North Transfer Station Stakeholder Group Compendium

Chapter 4: Workshop 1

Workshop 1: Sept. 14, 2010

North Transfer Station
Stakeholder Workshop #1 Summary
Sept. 14, 2010
Institute for Systems Biology • 5 to 8 PM

CONCEPT 7
NARROW

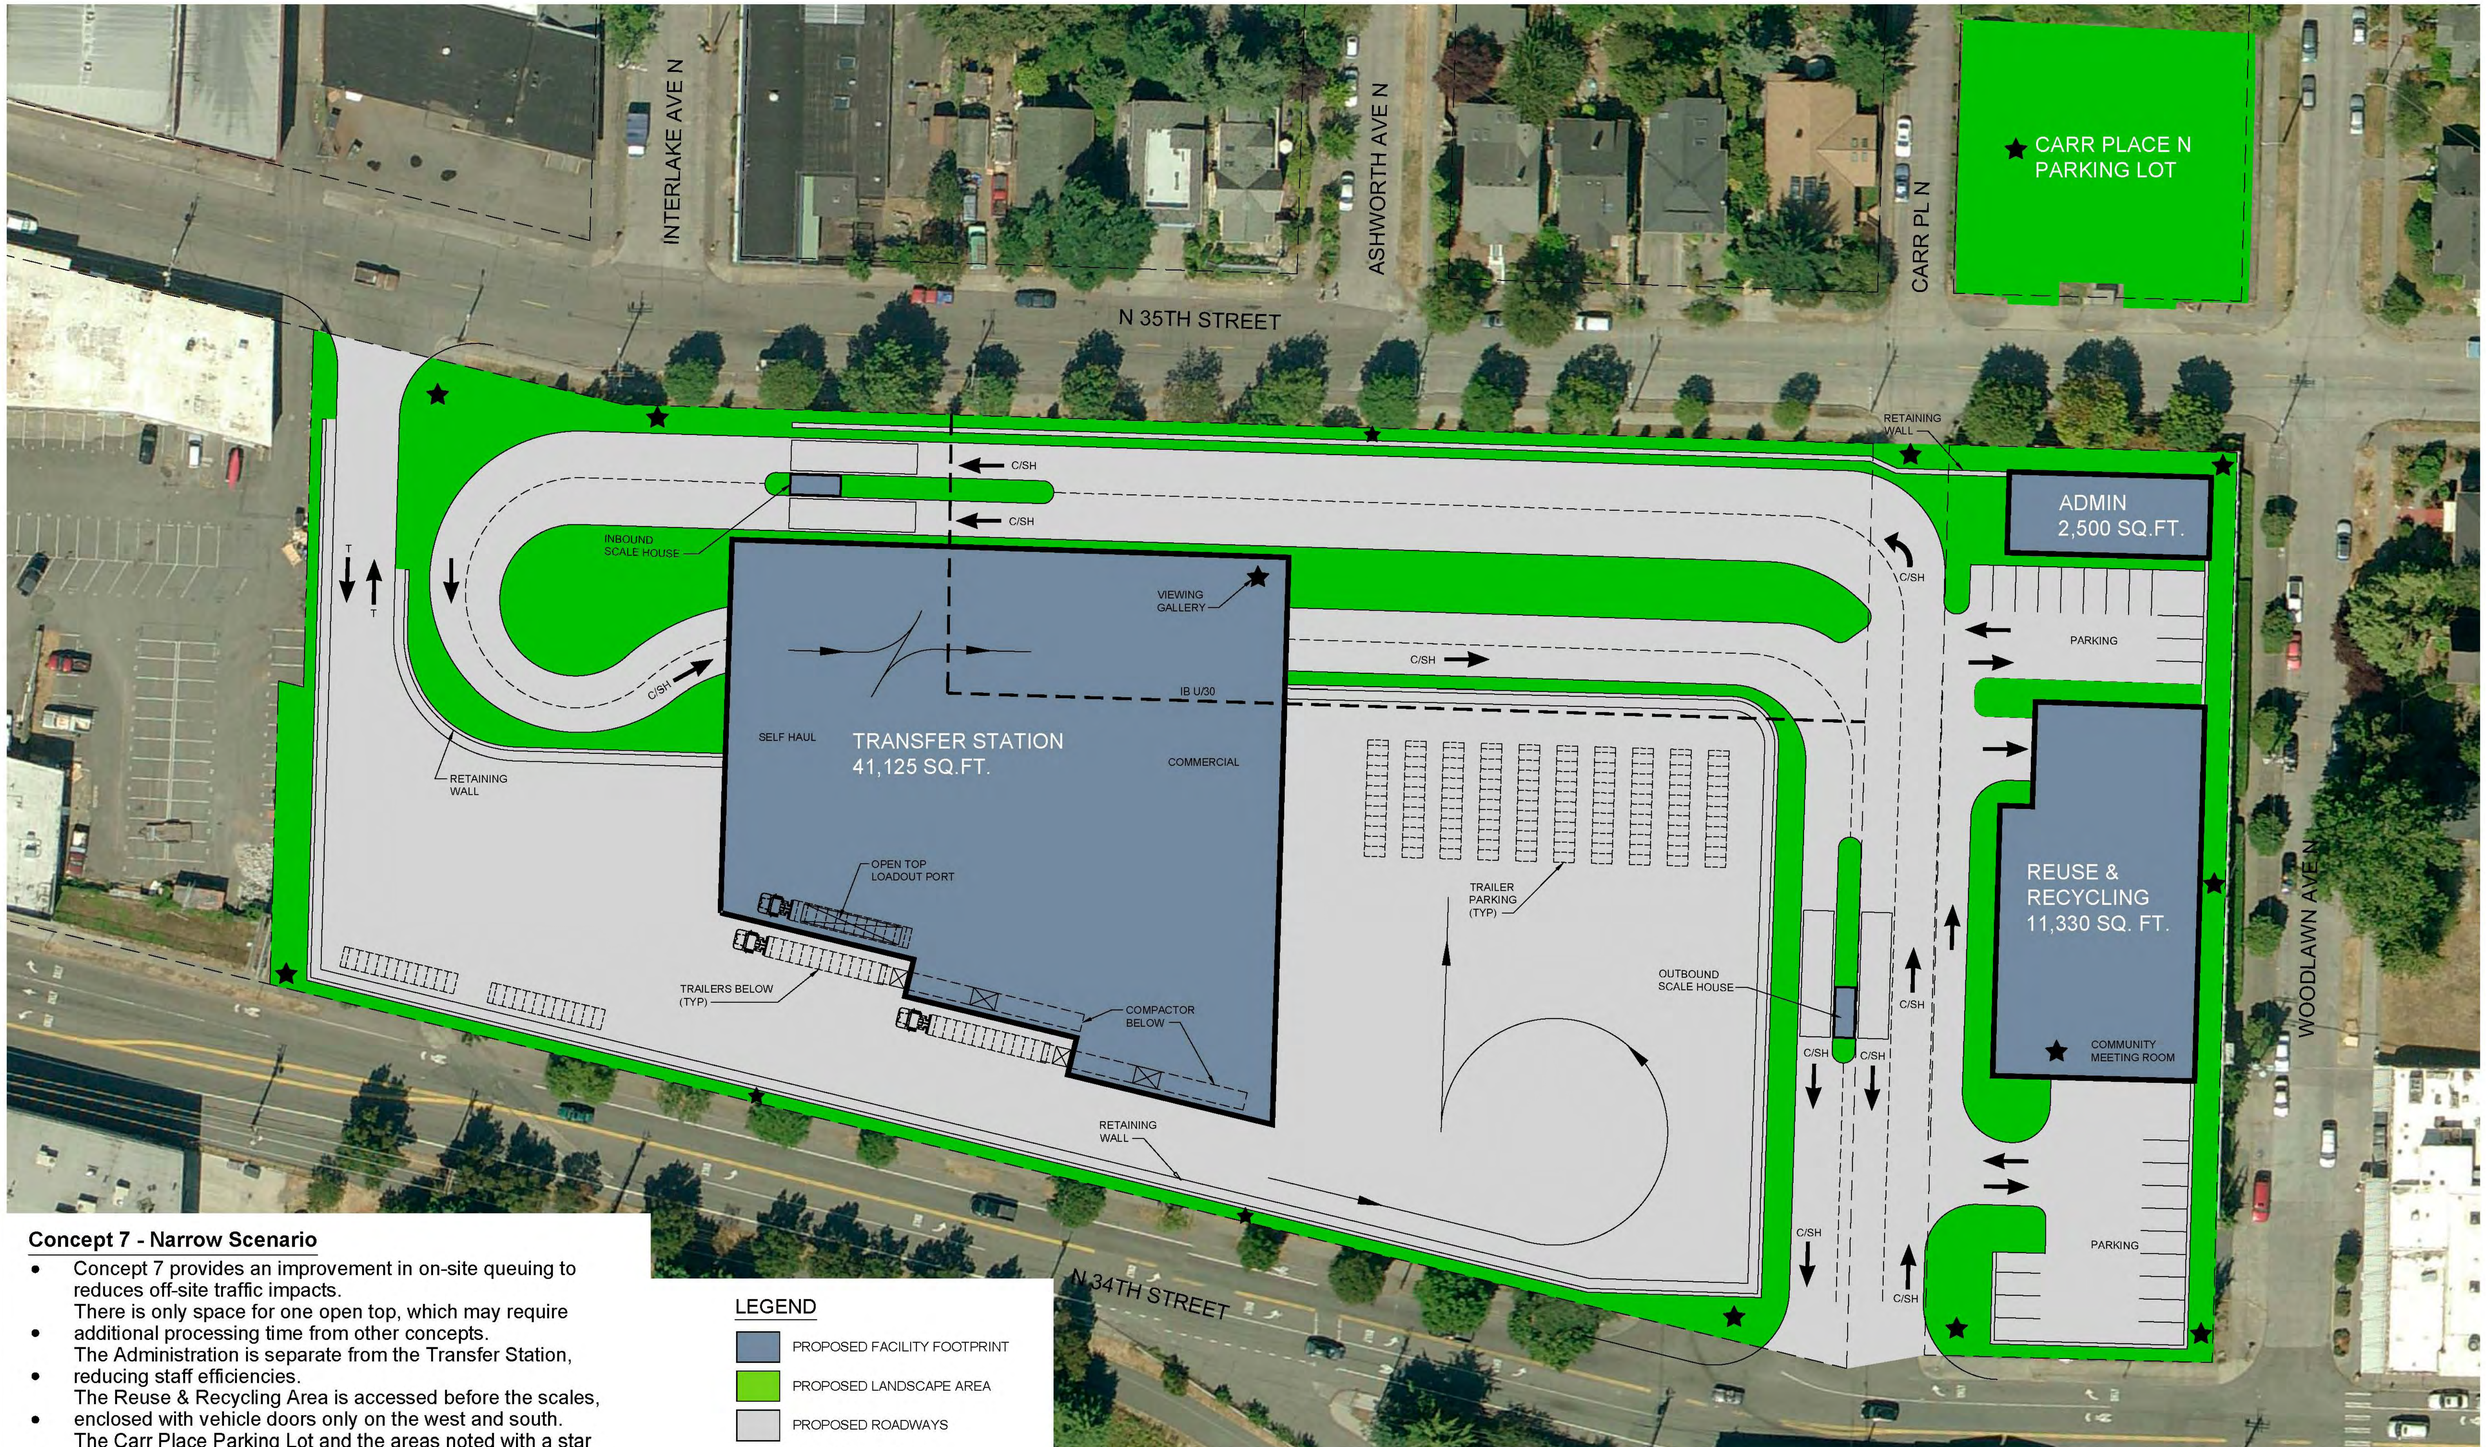
Concept 7 - Narrow
(S) Seems like a huge amount of space is devoted to truck trailer turnaround and parking.
(O) What will the noise pollution be from all the trucks (trailer parking)?
(O) What about slowing down traffic on N. 35th Street – going to the transfer station?
